U. S. ATOMIC ENERGY COMMISSION
DIRECTORATE OF REGULATORY OPERATIONS

RO Inspection Report No.: 50-219/73-04 Docket No.: 50-219
Licensee: Jersey Central Power & Light Co. License No.: DPR-16
Oyster Creek Priority: _____
_____ Category: C
Location: Forked River, New Jersey

Type of Inspection: Special

Dates of Inspection: March 13, 1973

Recirculation Loop Temp.
B Loop

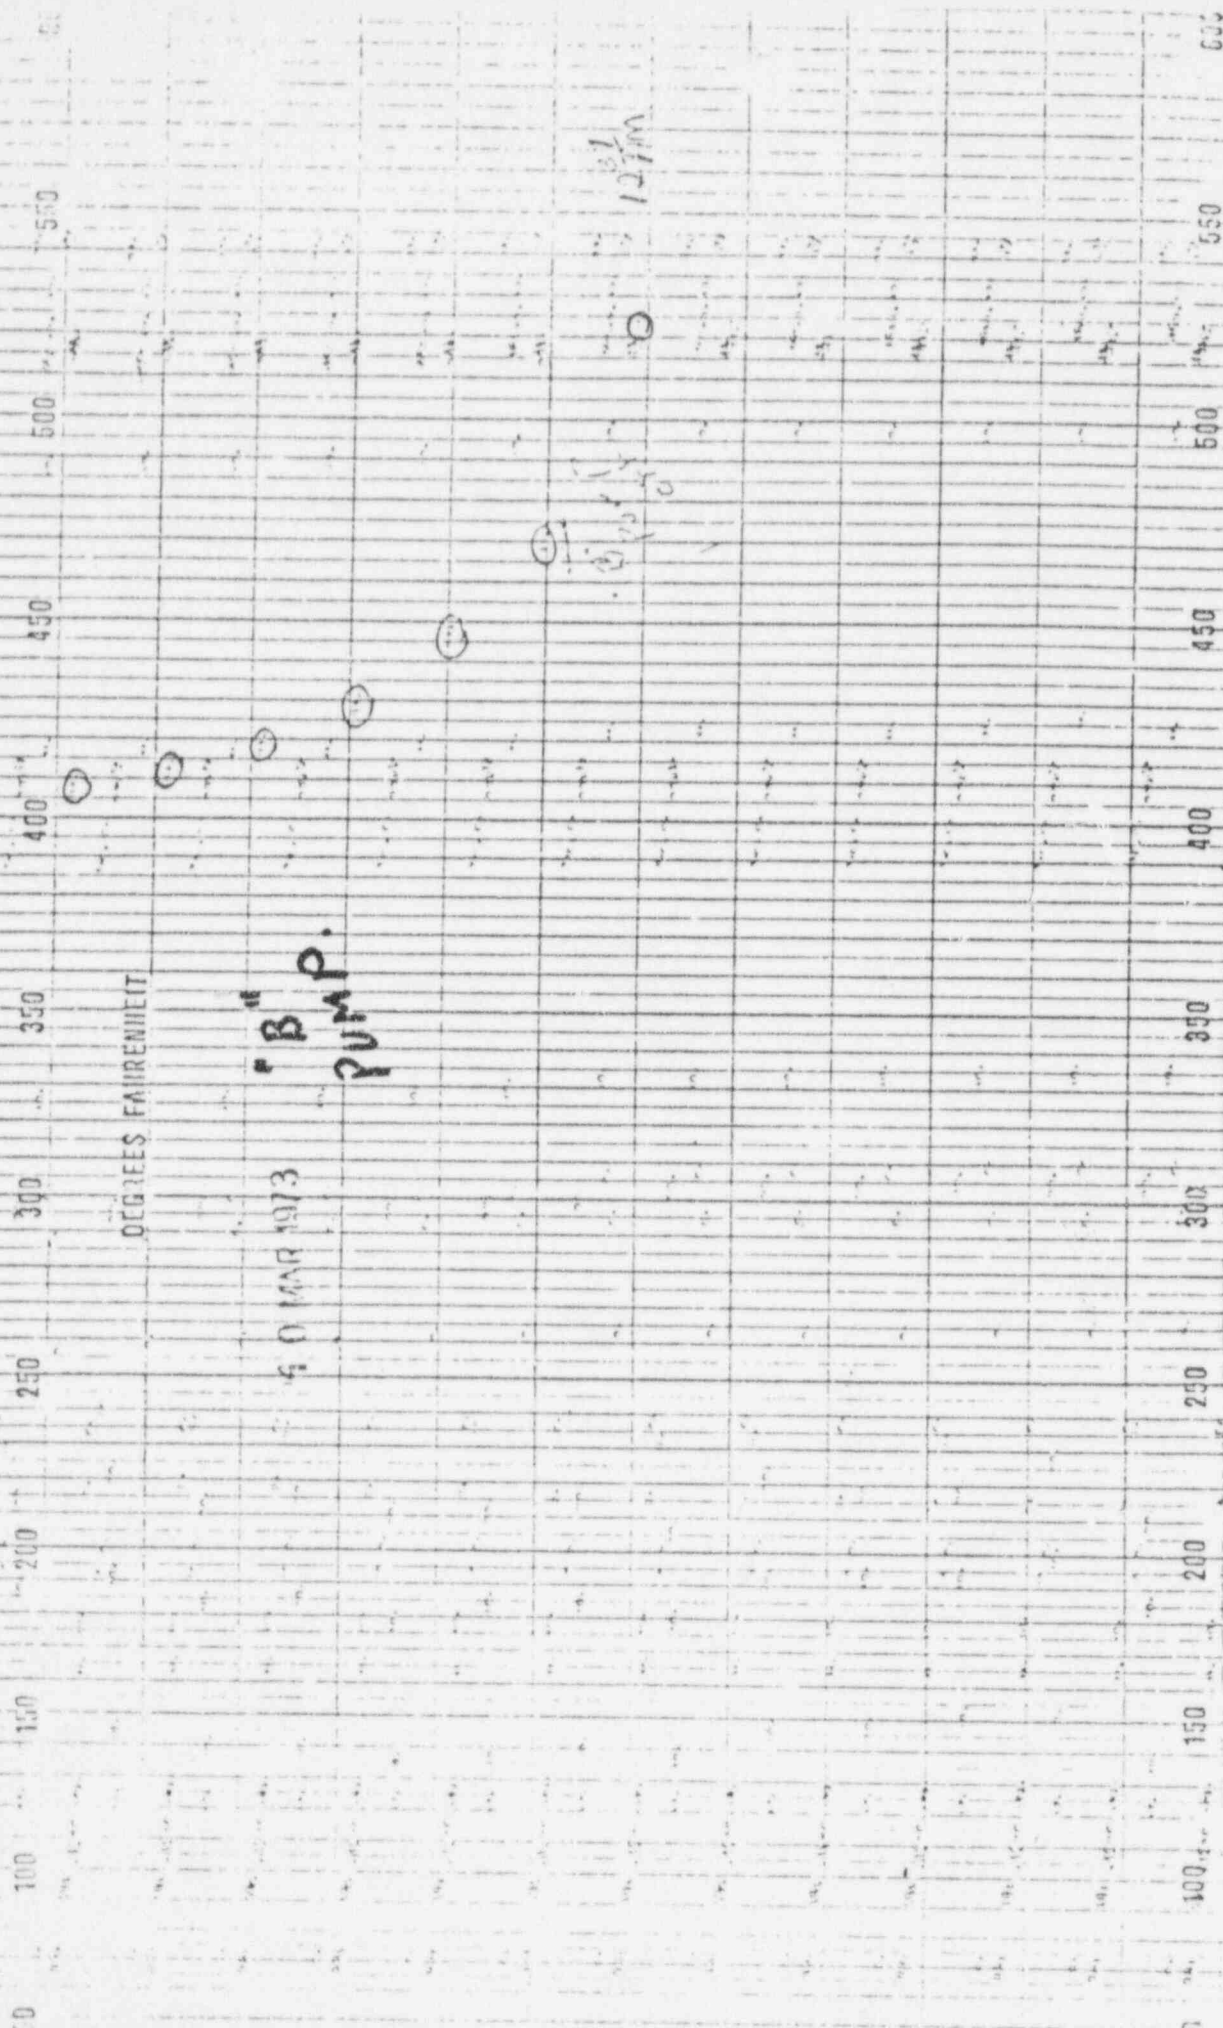
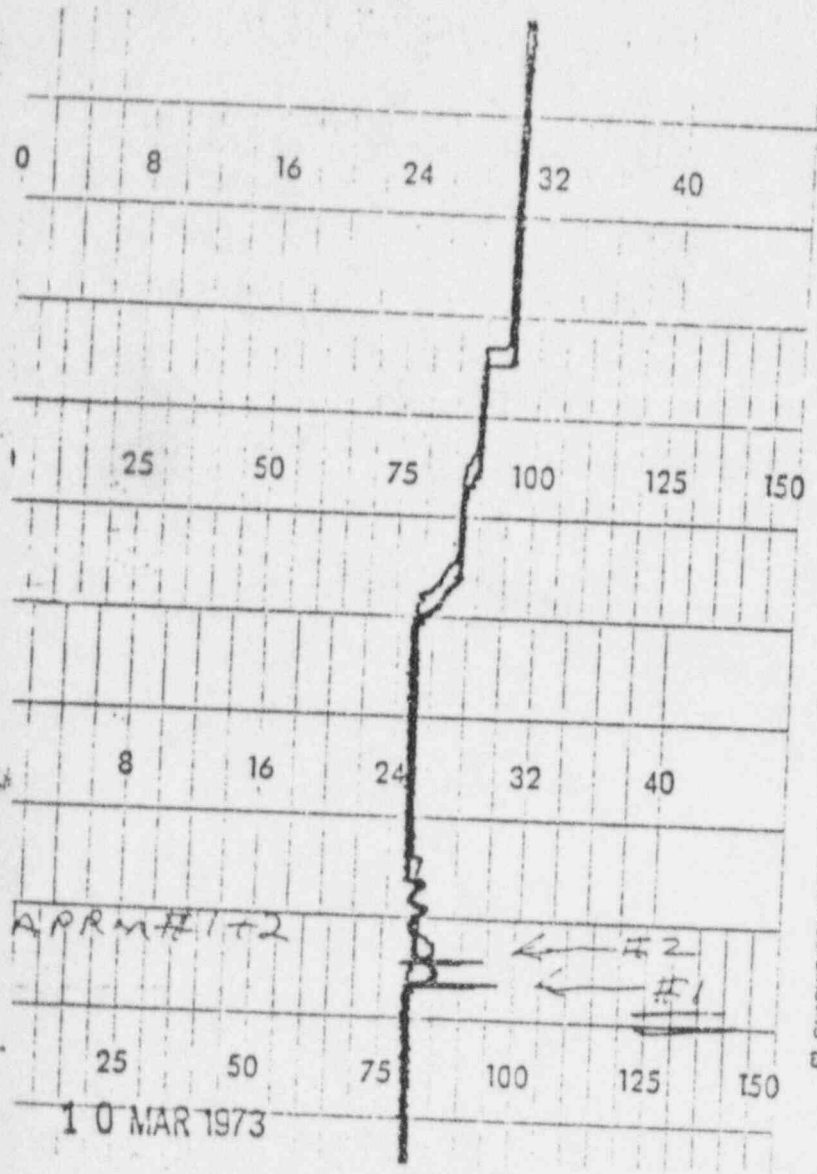
The B recirculation loop was returned to service on March 10, 1973 by opening the discharge valve, restarting the B recirculation pump and closing the bypass valve. At the time of this action, there existed a differential temperature of 117°F between the temperature of the reactor water and the loop water. Technical Specifications paragraph 3.3 prohibits restarting an idle loop unless the temperature of the coolant within the idle recirculation loop is within 50°F of the reactor coolant temperature.

The B recirculation loop had been removed from service to replace brushes on the MG set that supplies power to the recirculation pump motor at 12:30 AM on March 10, 1973 by closing the pump discharge valve, opening the bypass around the discharge valve, and de-energizing the MG sets. Opening the bypass valve permits backflow through the recirculation loop and normally maintains the coolant temperature in the loop within approximately 10°F of the reactor coolant temperature, however, operating personnel did not consider the effect of continued operation of the cleanup system on idle loop temperature. The clean up system is fed from the B loop, upstream of the suction valve, and discharges to the B loop, downstream of the discharge valve. With the loop discharge valve closed and the bypass valve open, the colder water from the clean up system backflowed through the bypass valve gradually lowering the temperature of the water in the recirculation pump and the temperature of the feedwater to the clean up system. The recorder for the recirculation loop temperature showed that the B loop temperature dropped approximately 117°F while the loop was isolated and increased the same amount when the pump was restarted approximately 2 hours later (Attachment 1). The recorders for the average power range monitors (APRM) in the same quadrant as the B recirculation loop showed that the flux increased approximately 17% when the pump was restarted (Attachments 2 and 3). This flux increase is attributed to the associated increase in recirculation flow when the recirculation pump was restarted, and to a negative moderator temperature coefficient. Rod block alarms were received when the pump was restarted, but the flux increase was less than that required to initiate a high flux scram. The narrow range reactor pressure recorder showed a pressure surge of 4-5 psig at the time the B recirculation pump was restarted.

Average Power Range Monitor Charts
Attachment No. 2

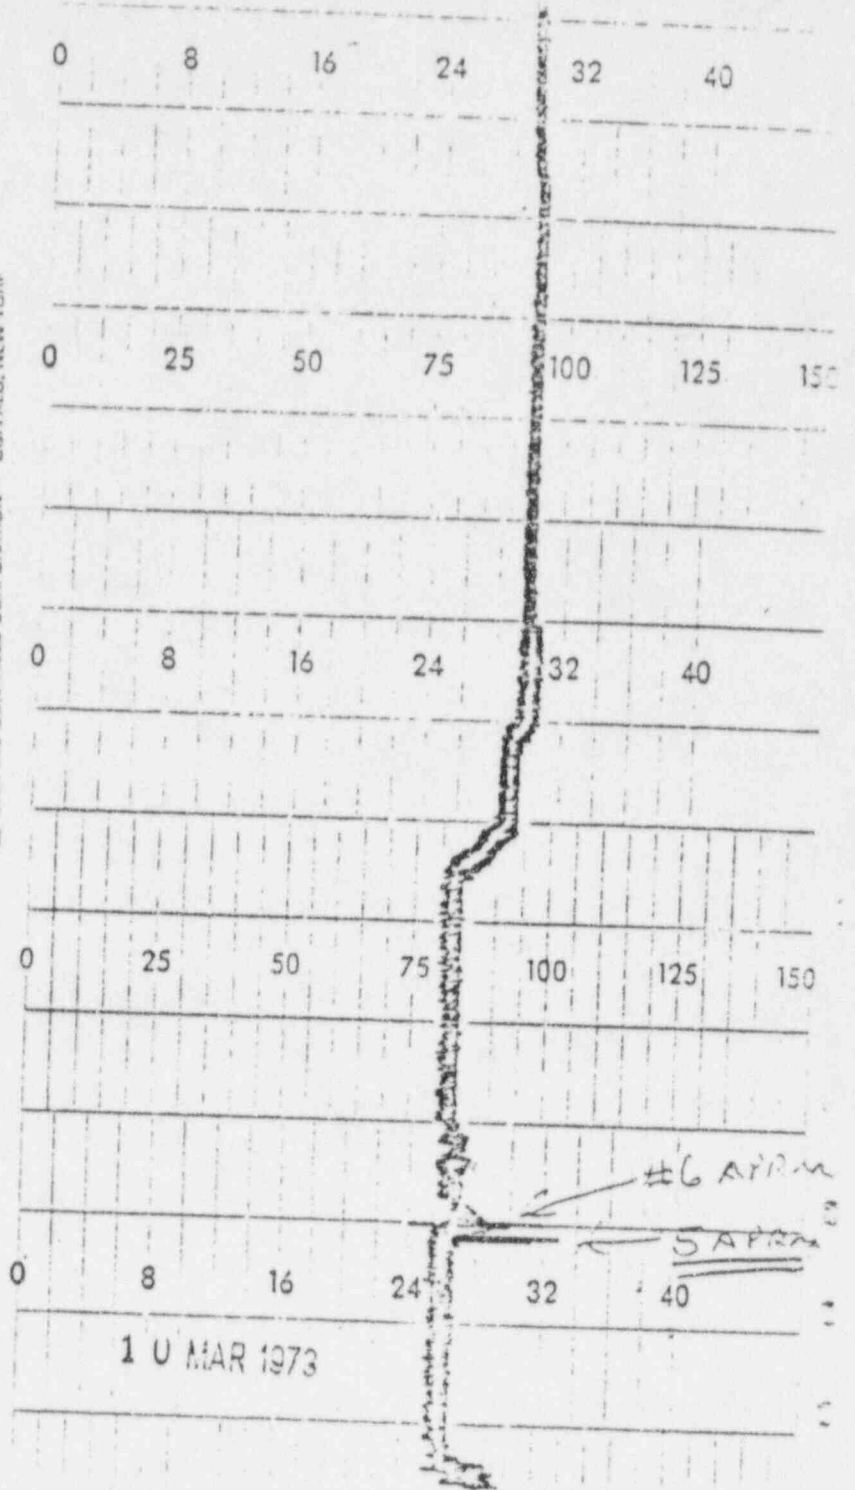
The B recirculation loop was returned to service on March 10, 1973 with a differential temperature of 117°F between the temperature of the reactor coolant and the temperature of the coolant in the idle loop. The APRM recorders in the same reactor quadrant as the B recirculation loop showed that the flux increased approximately 17% when the pump was restarted.
